DOMINION ENERGY KEWAUNEE, INC.
KEWAUNEE POWER STATION
LICENSE AMENDMENT REQUEST 246: REVISION TO REACTOR COOLANT
SYSTEM PRESSURE AND TEMPERATURE LIMITS AND LOW TEMPERATURE
OVERPRESSURE PROTECTION LIMITATIONS

**LICENSE AMENDMENT 246
REACTOR COOLANT SYSTEM PRESSURE AND TEMPERATURE LIMITS AND
LOW TEMPERATURE OVERPRESSURE PROTECTION**

LICENSE AMENDMENT 246
REVISION TO REACTOR COOLANT SYSTEM PRESSURE AND TEMPERATURE
LIMITS AND LOW TEMPERATURE OVERPRESSURE PROTECTION LIMITATIONS

**FIGURE TS 3.1-1
KEWAUNEE POWER STATION UNIT NO. 1 HEATUP LIMITATION CURVES
APPLICABLE FOR PERIODS UP TO 52.1 EFFECTIVE FULL-POWER YEARS**

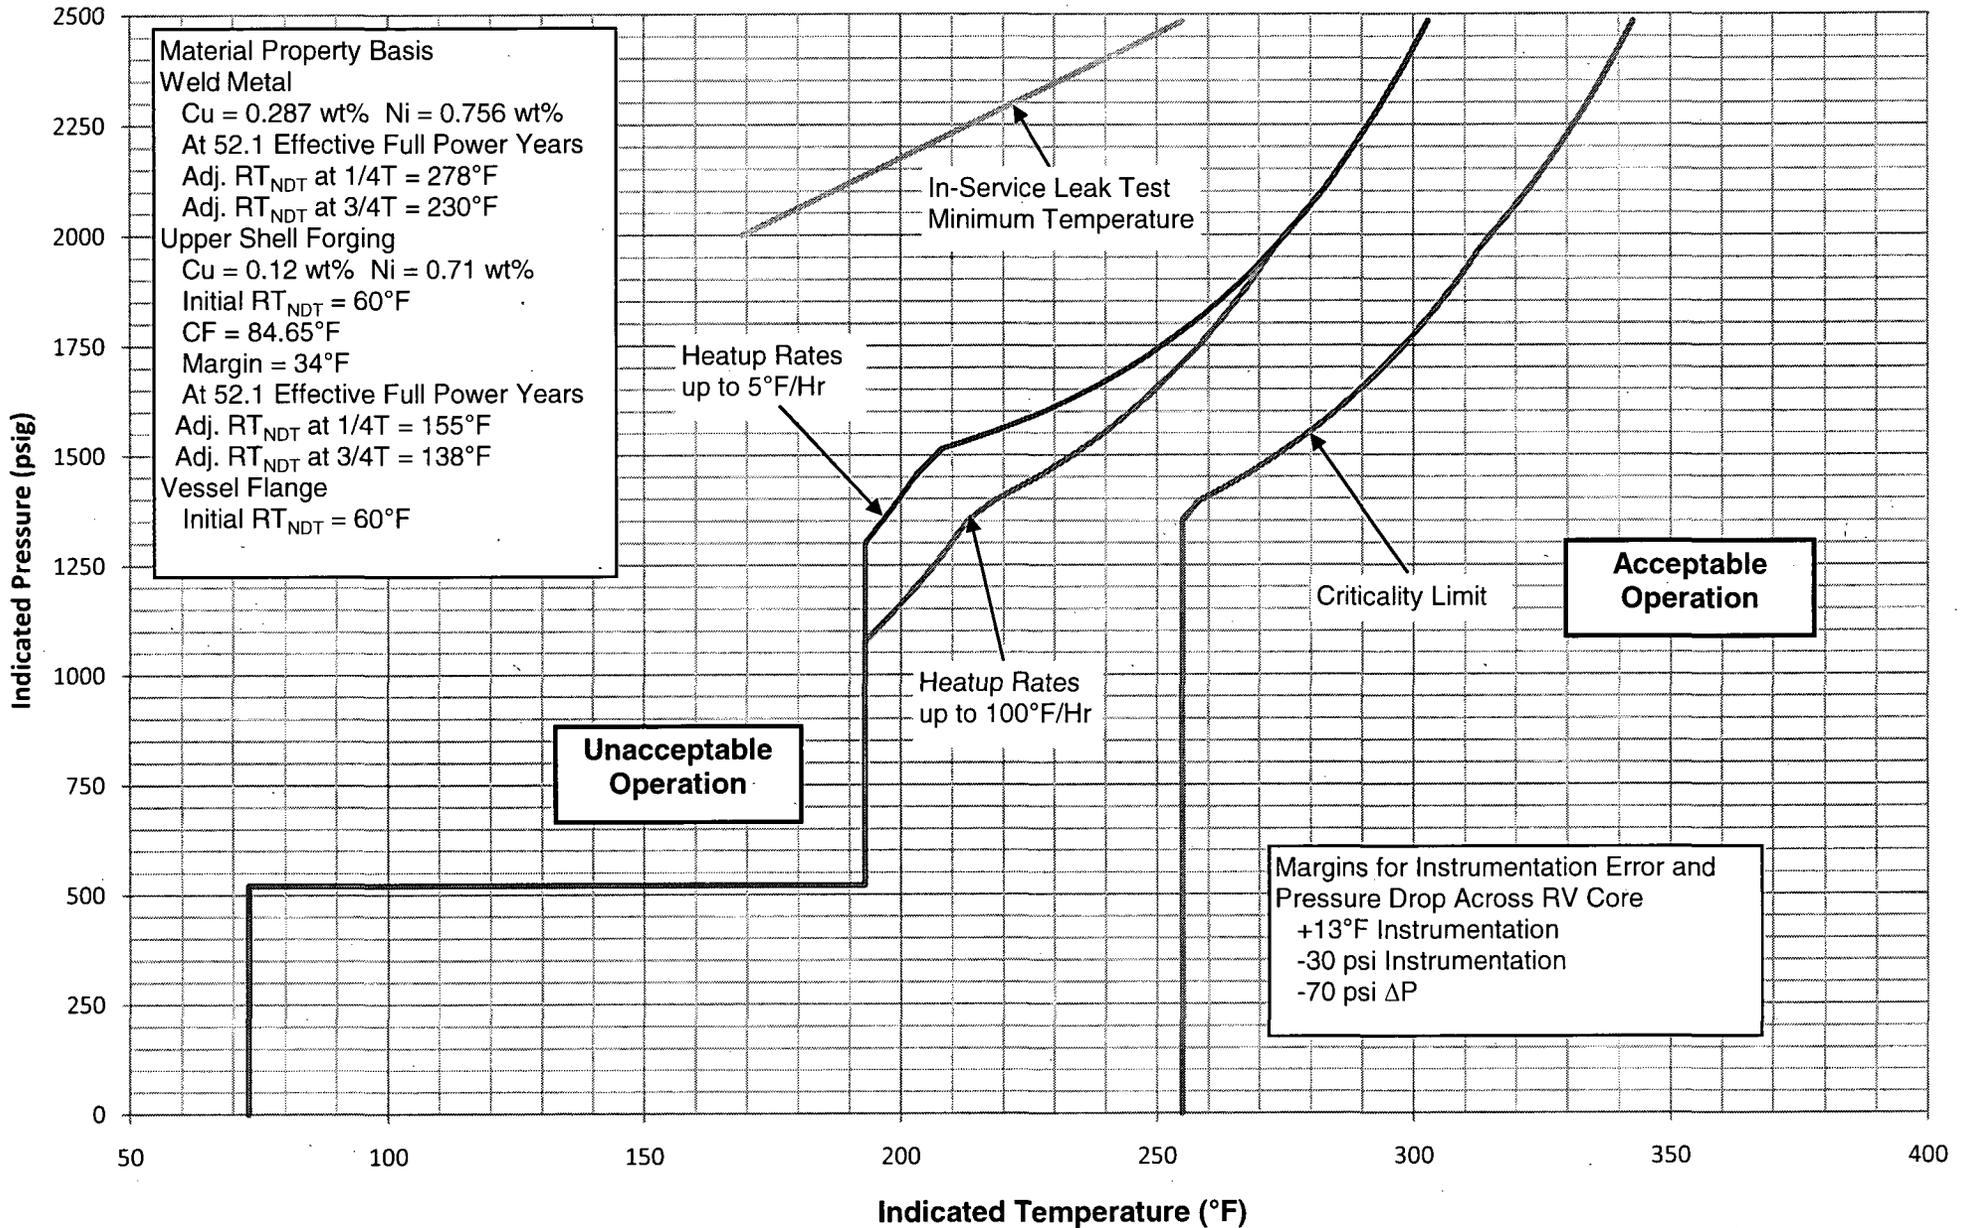
1. TS 3.1.b.1 is modified to address applicability of Figure TS 3.1-1 and Figure TS 3.1-2 for a service period of up to 52.1 EFPY. The present footnote in each of the figures stating that the curves are limited to 31.1 EFPY is deleted, because the proposed new pressure and temperature limitation curves are applicable through 52.1 EFPY. This change makes TS 3.1.b.1 consistent with the expiration date noted on the revised heatup and cooldown P/T limit curves.

3. Figure TS 3.1-1 and Figure TS 3.1-2 have been modified using the NRC-approved methodology to meet the requirements of 10 CFR 50, Appendix G, for pressure and temperature (P/T) limitations applicable during a service period of up to 52.1 EFPY. The new figures provided in Attachment 2 replace, in their entirety, the corresponding figures in the current KPS TS.
4. TS Basis Section 3.1 has been revised accordingly (including footnote revisions).
5. The list of TS figures has been modified to address the new applicability period of 52.1 EFPY for Figure TS 3.1-1 and Figure TS 3.1-2.

- C. The isothermal curve in Figure TS 3.1-2 and 5°F/hr curve in Figure TS 3.1-1 defines limits to assure prevention of non-ductile failure applicable to low temperature overpressurization events ~~only~~. Application of ~~this~~ these curves is limited to evaluation of LTOP events whenever one or more of the RCS cold leg temperatures are less than or equal to the LTOP enabling temperature of ~~200~~343°F.

⁽⁴⁾ ~~The curves are limited to 31.1 EFY due to changes in vessel fluence associated with operation at uprated power.~~
